Docket Number:	25-BSTD-03
Project Title:	2028 Energy Code Pre-Rulemaking.
TN #:	266909
Document Title:	Greg Danenhauer Comments - Boiler Rules
Description:	N/A
Filer:	System
Organization:	Greg Danenhauer
Submitter Role:	Other Interested Person
Submission Date:	10/29/2025 2:12:42 PM
Docketed Date:	10/29/2025

Boiler Rules

PARKER BOILER CO.

Load Profiles

1.) Battle Creek VA -Process Steam less Laundry

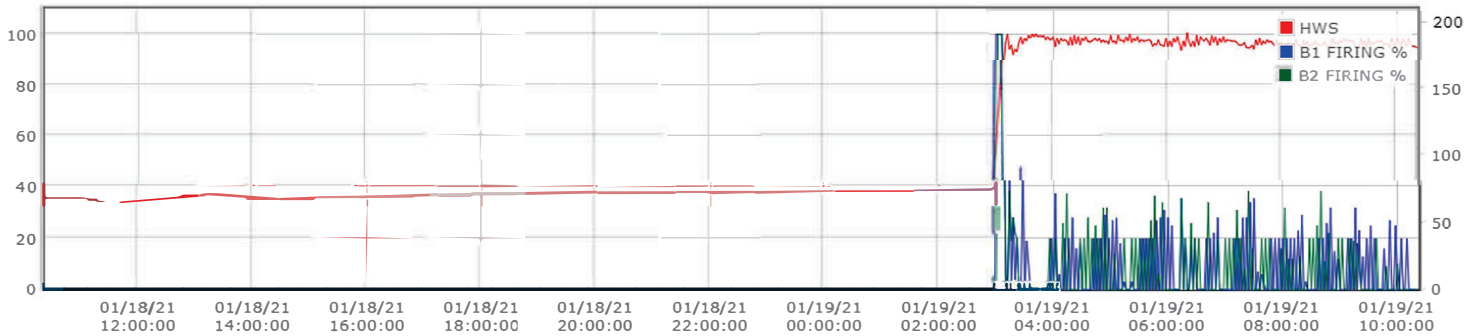
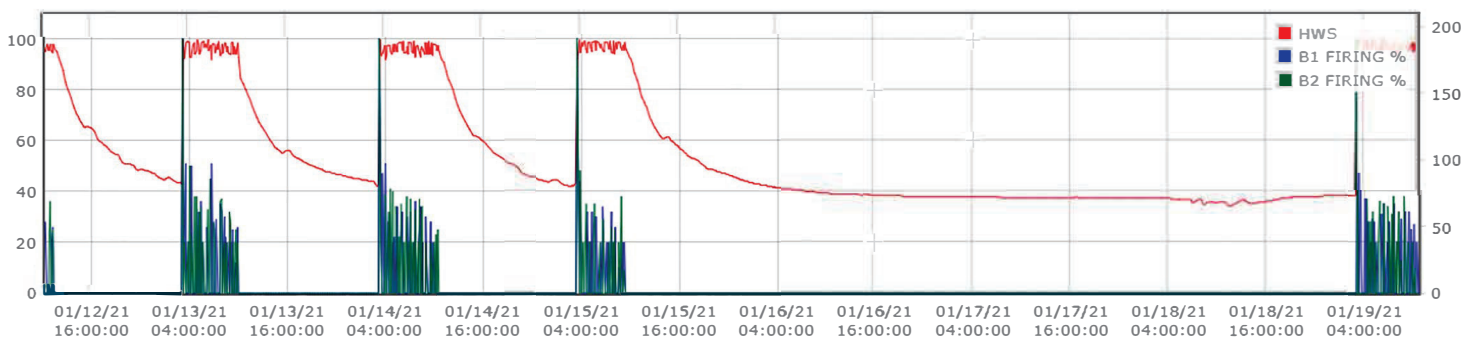
As you can see from the 7 day & 24 hour views the boilers are started about 3 in the morning and shut off about noon. So, it appears these boilers start about 5 times per weeks & the fluid temperature drops to under 100°F.

VA LITTLE ROCK

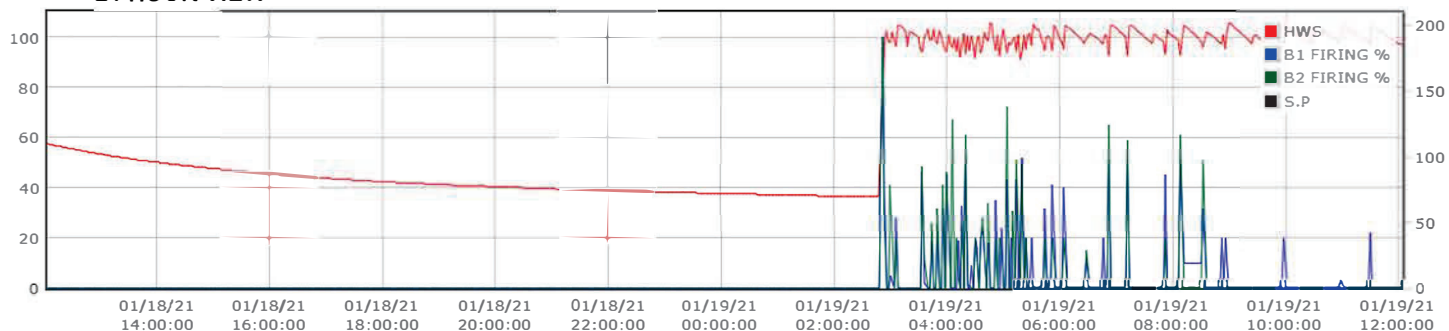
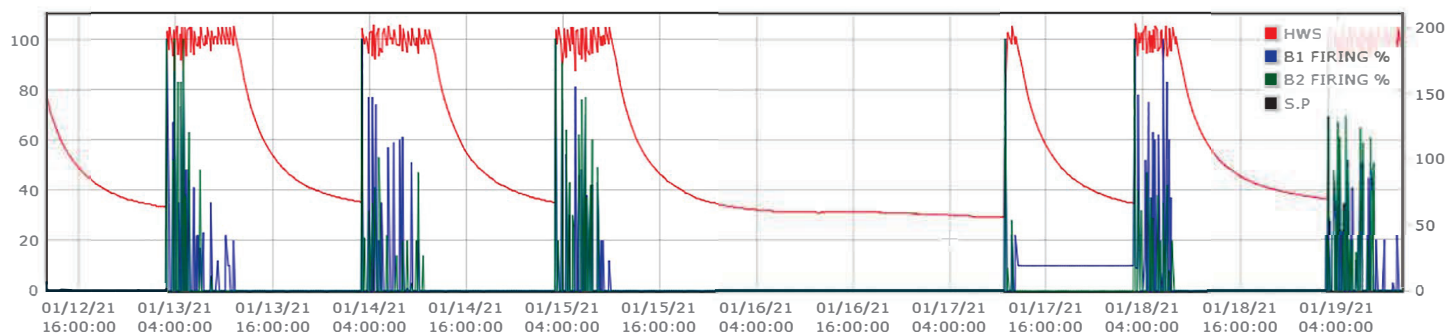
As you can see from the 7-day & 24 hour views the boilers are started about 3 in the morning and shut off about noon. So, it appears these boilers start about 5 times per weeks & the fluid temperature drops to under 100°F.

3.) Seismic -Food / Drink Process

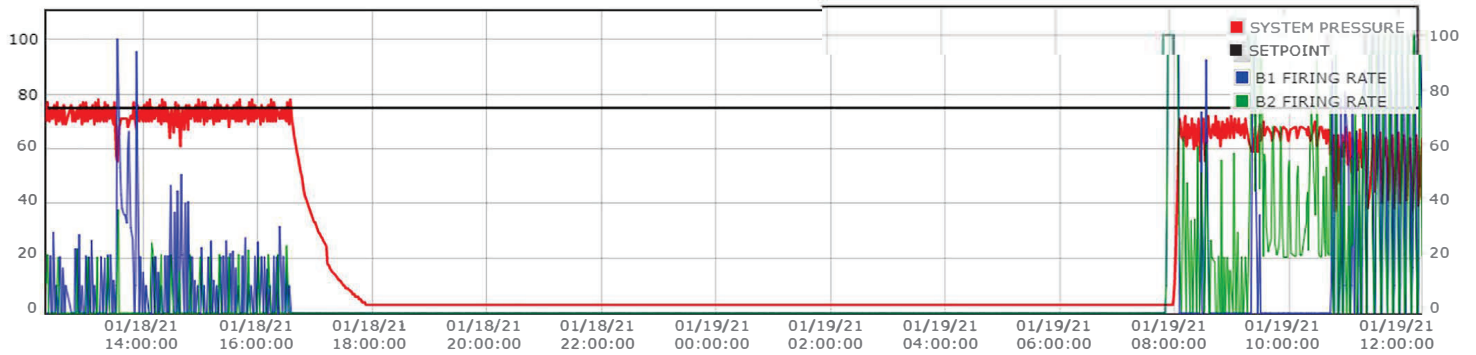
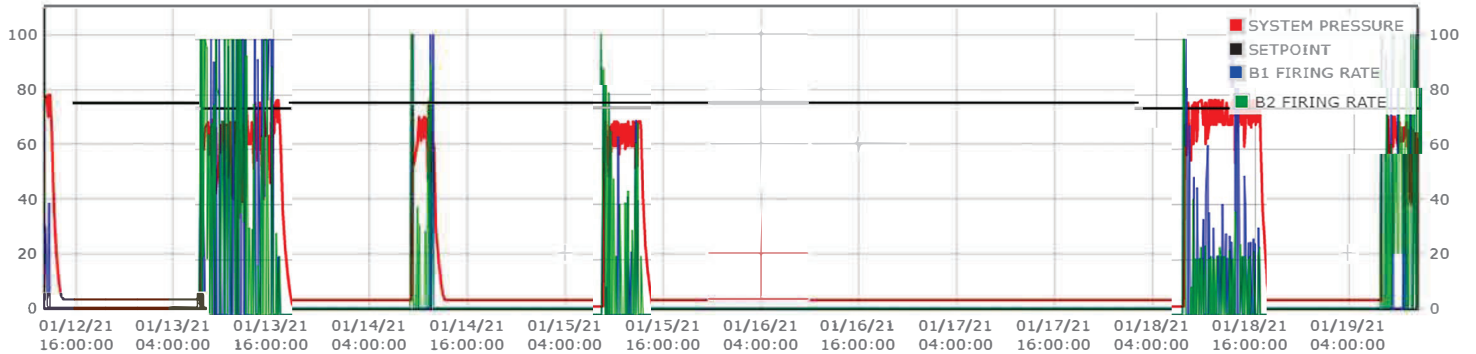
As you can see from 7-day & 24 hour views the boilers seem to be started daily on weekdays and the daily hourly use of the boiler likely depends on product demand.

4.) Spica - Process to Make Varnish

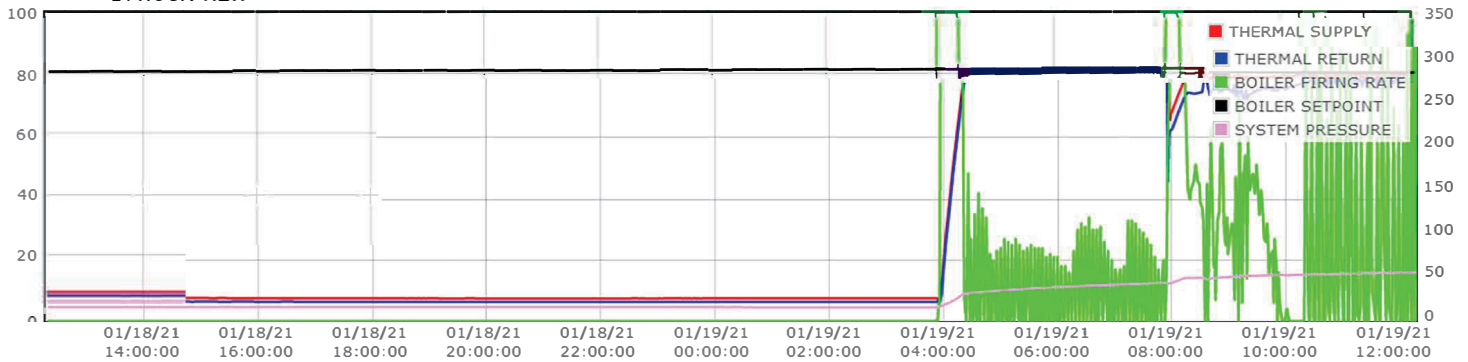
As you can see form the 7 day & 24 hour views the boiler is started perhaps 1-3 times per week.
